ADDENDUM No. 1

RFP No. 23-10

Research Park Drive Resurfacing Project

DRAWING NO. **2022-035-20**
 SHEET NO. **20 OF 41**

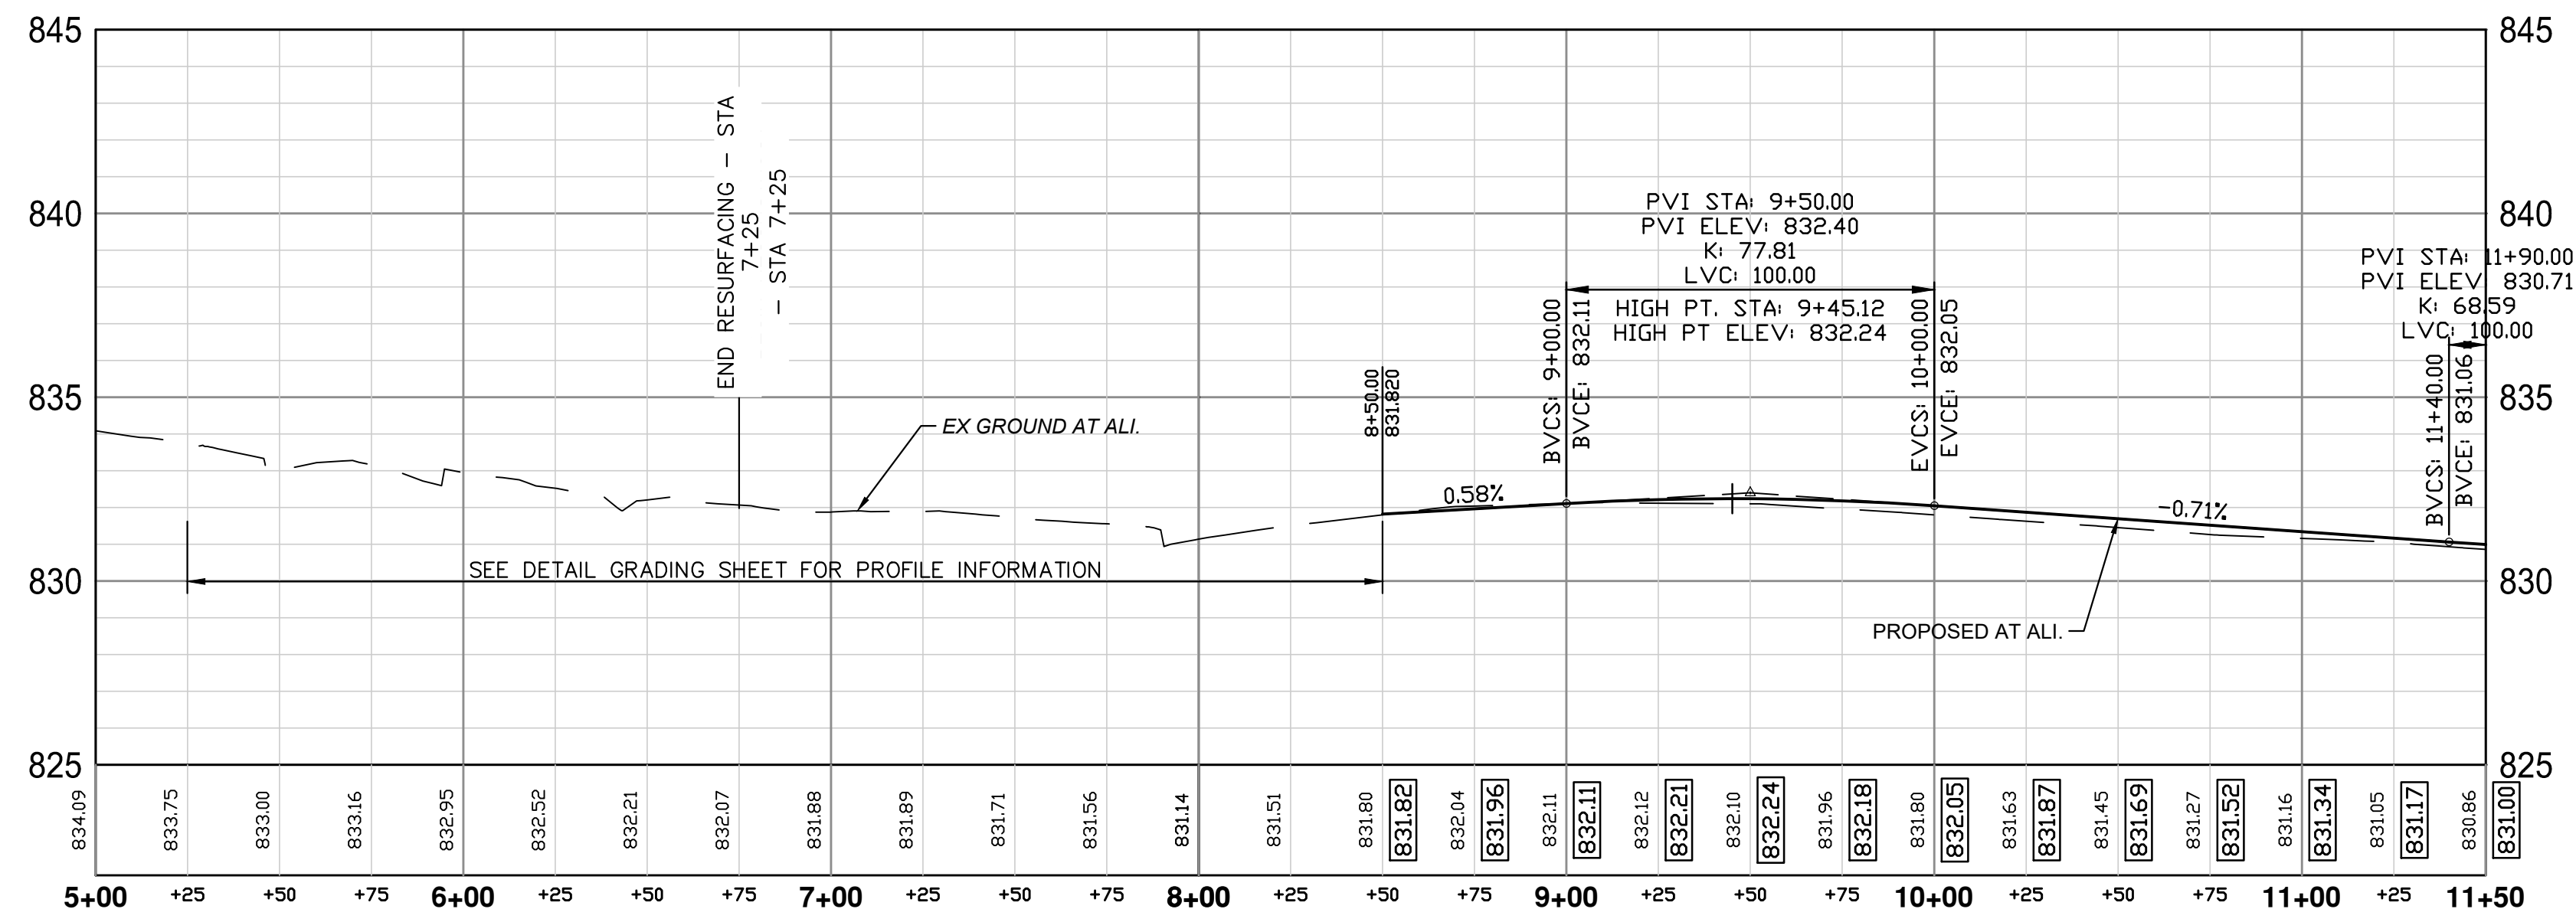
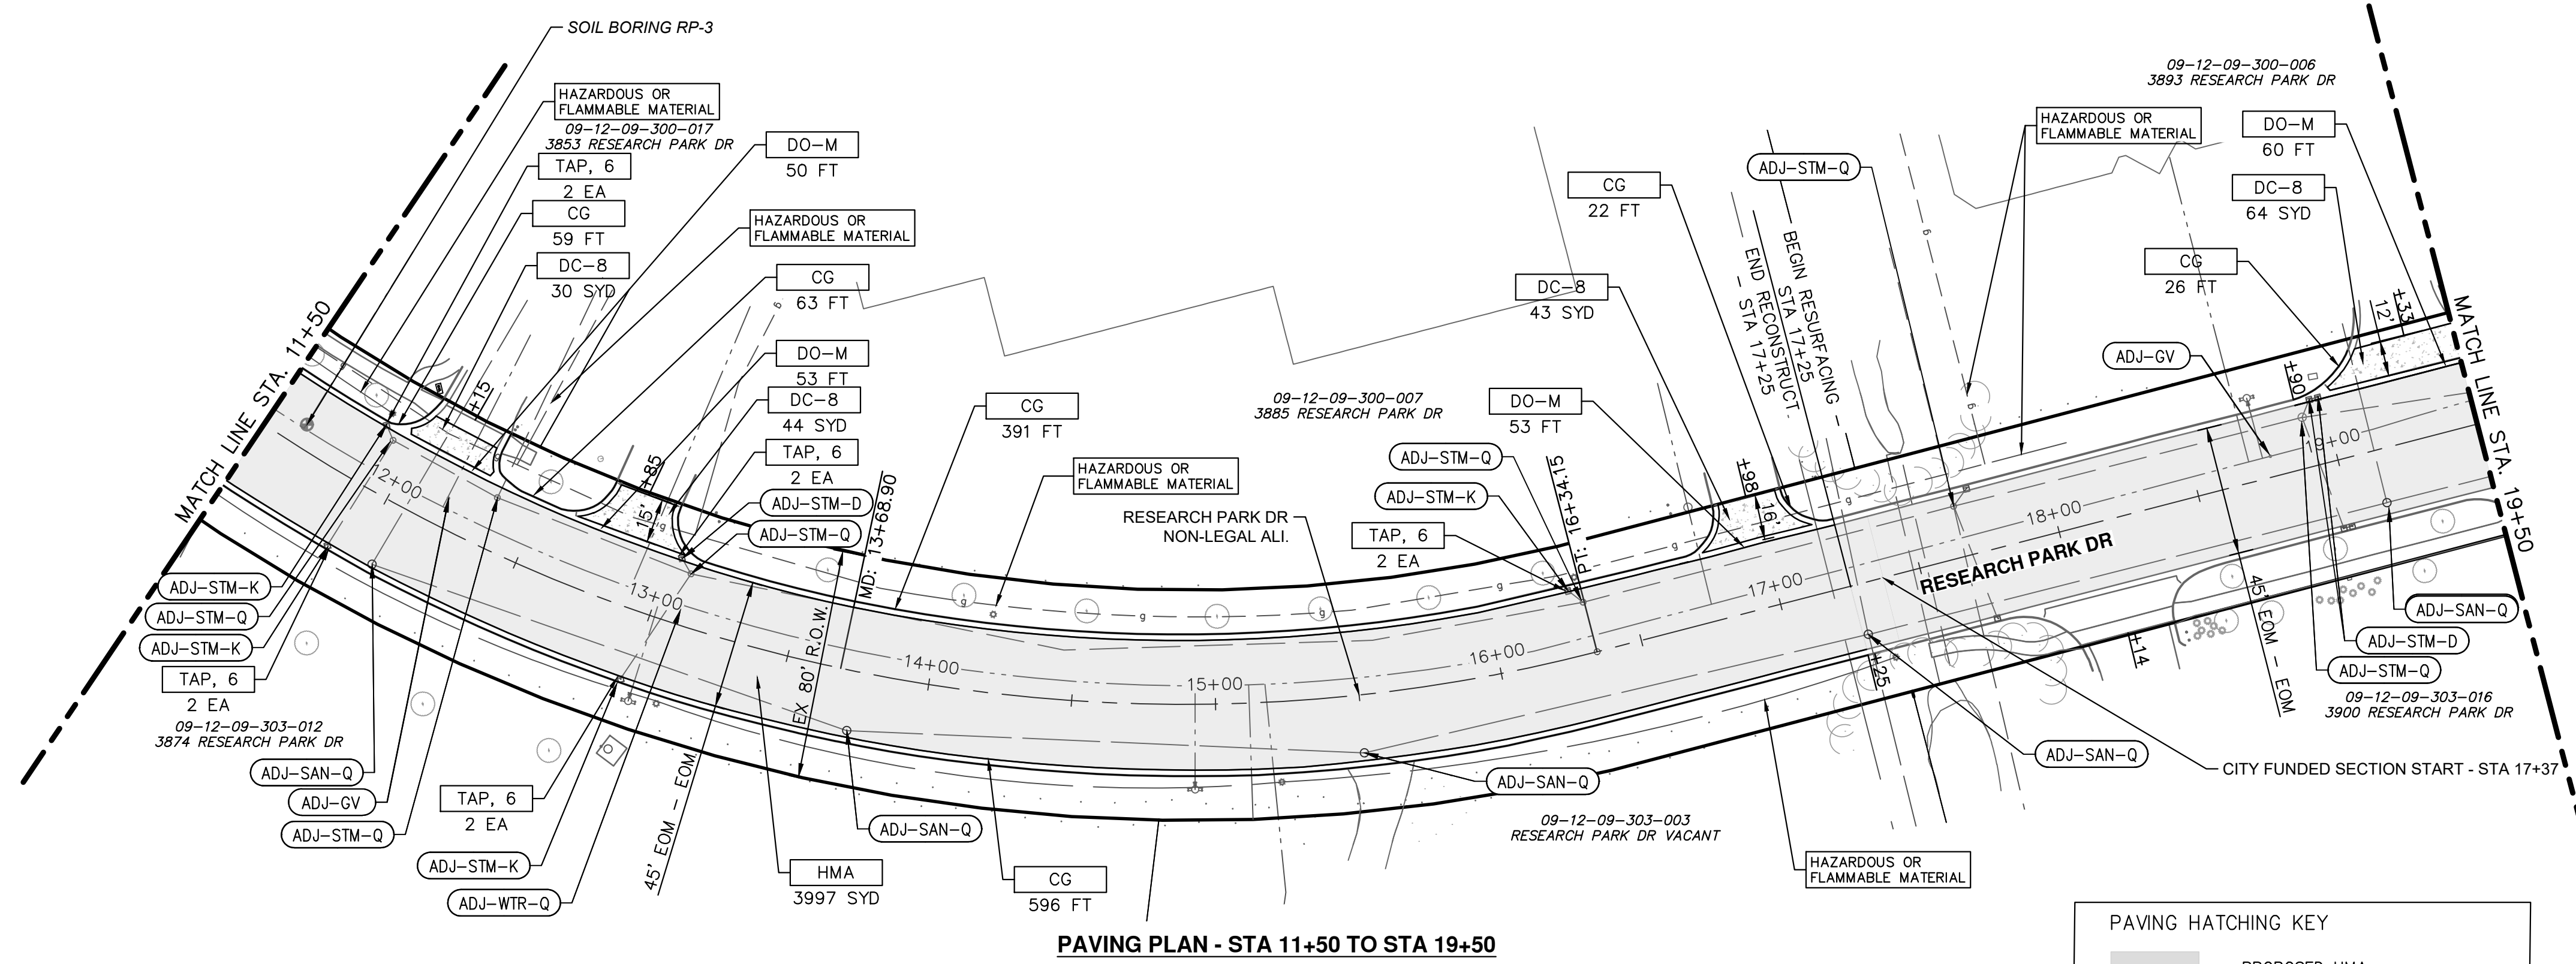
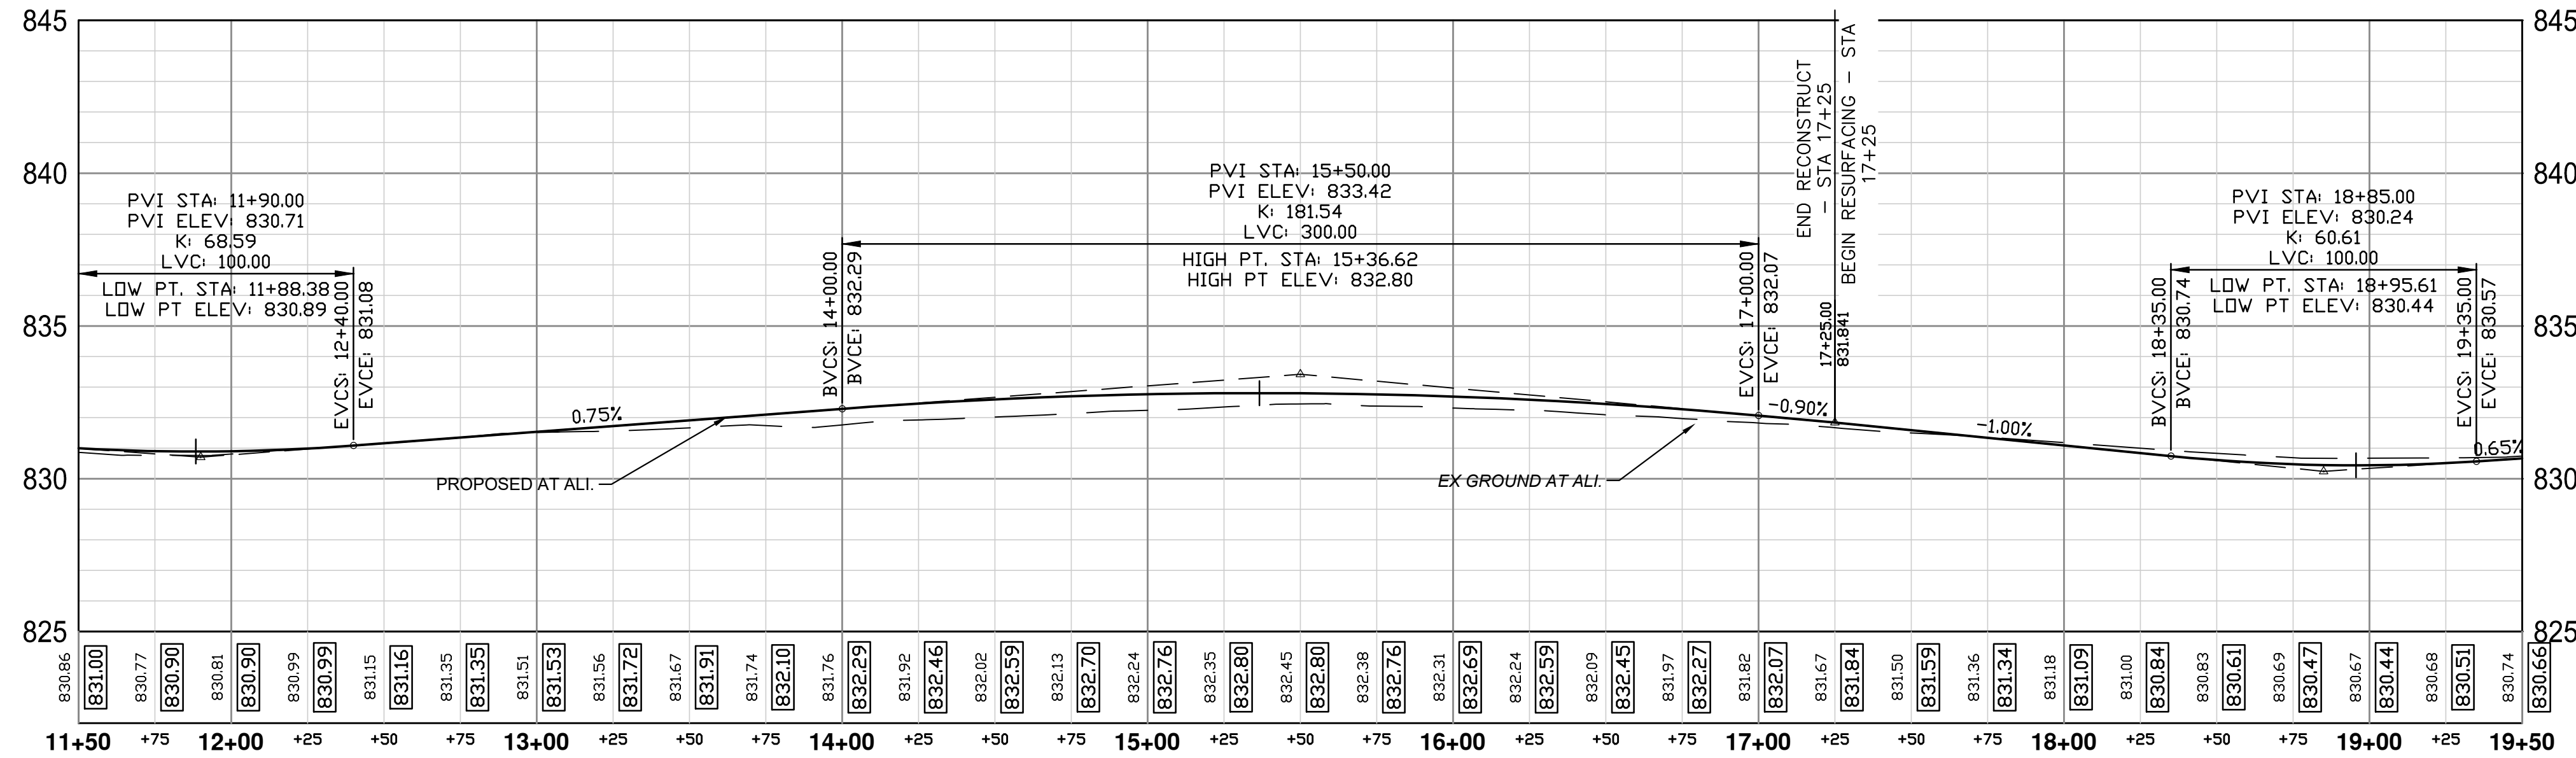
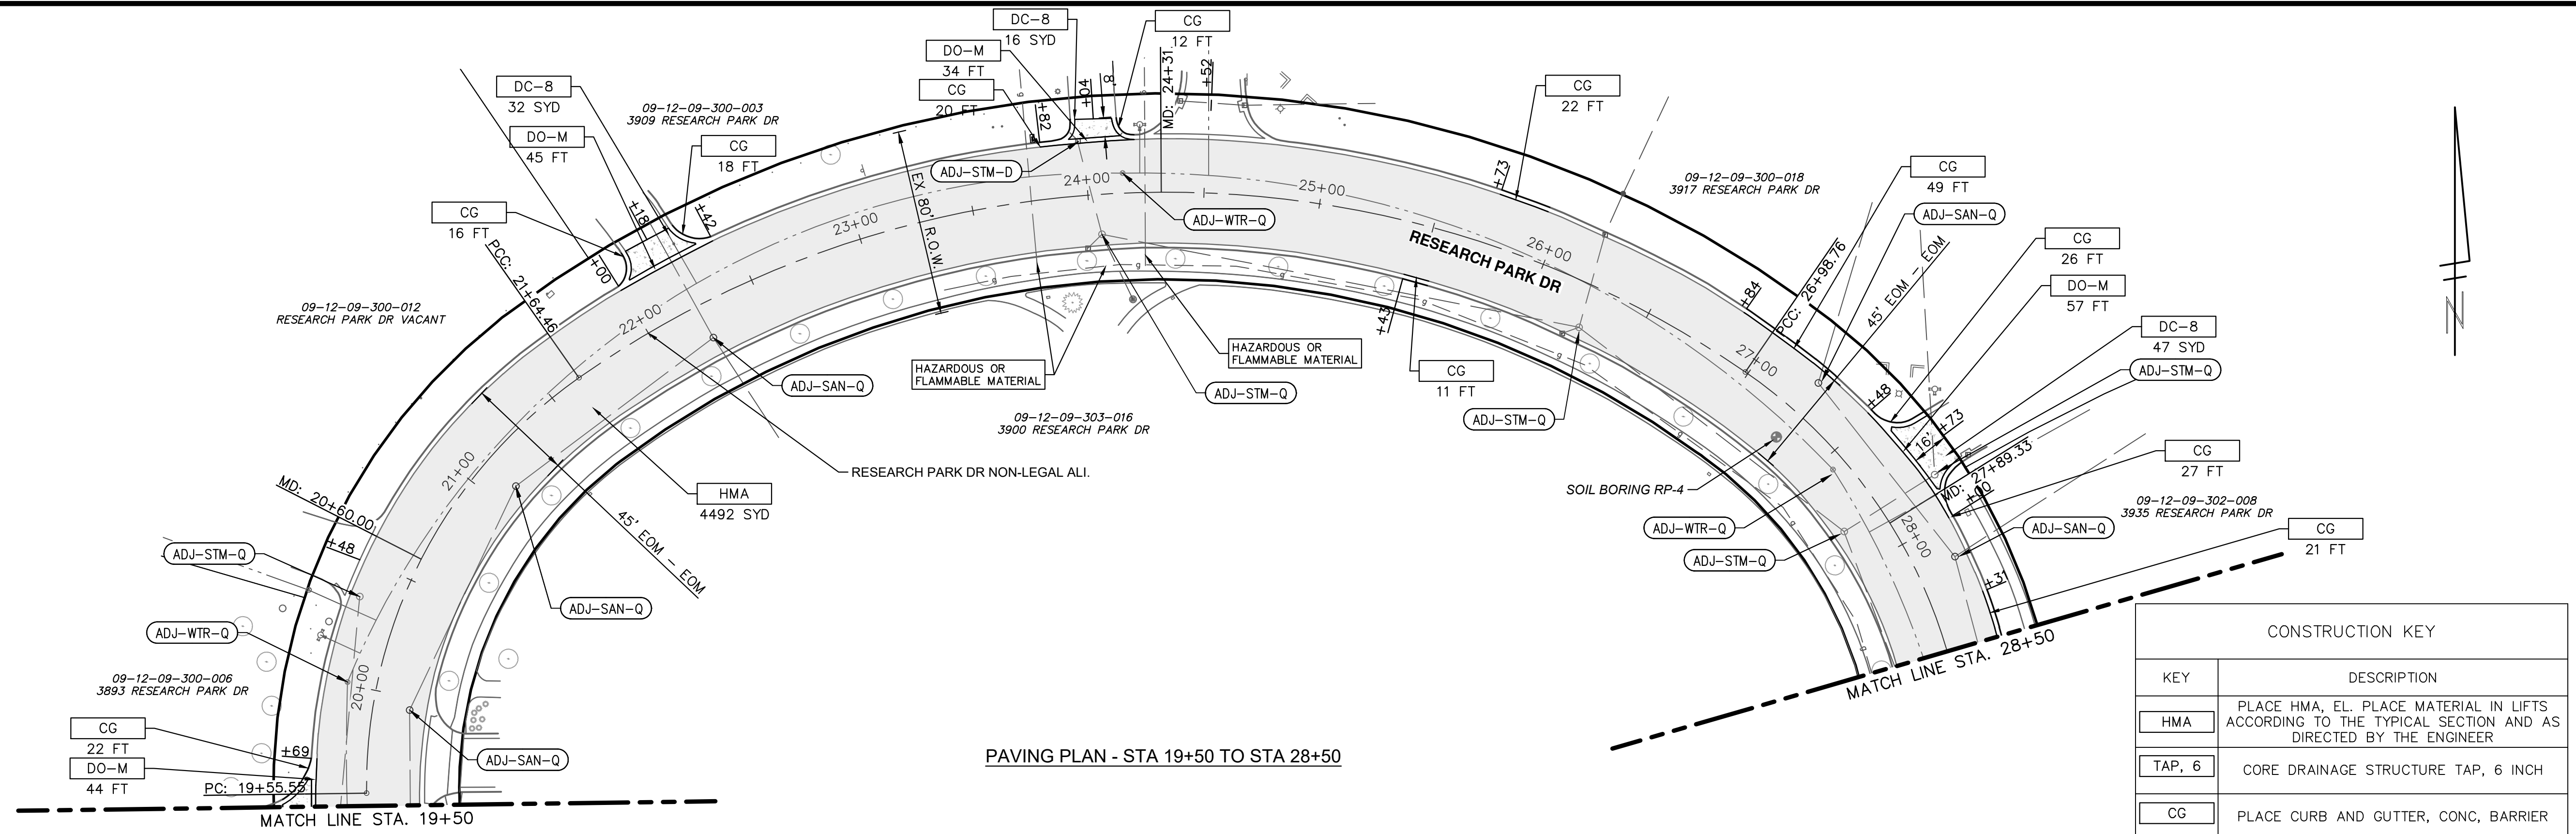
Sheet 9	Revised call outs on proposed typical section related to hot mix asphalt leveling and top courses. Revised HMA Application Table
Sheets 10-13	Revised call outs on proposed typical sections related to hot mix asphalt leveling and top courses.
Sheets 20-27	Revised call outs related to storm structure covers and adjustments.
